Below are comments for four different agenda items of the 1-30-2024 Transportation Commission meeting.

**81632 Endorsing / prioritizing bike/ped connectivity as part of WisDOT's I-39/90/94 study**

## 81653 Adopting the Lake Monona Waterfront Master Plan

## 81580 State Street 2024 Pedestrian Mall Experiment

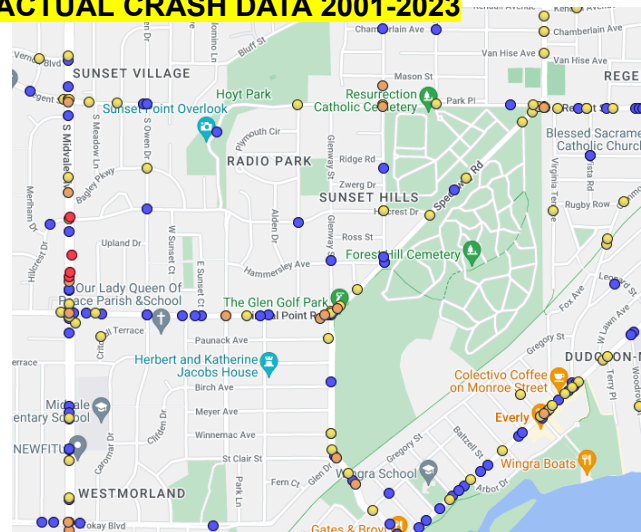
I support the Master Plan, but am disappointed it excludes the bike/ped area along Monona Terrace. Early in the competition, design firms offered these exciting renderings of what could be done in that area:

It would be nice if the master plan explained why this important area was excluded from consideration.
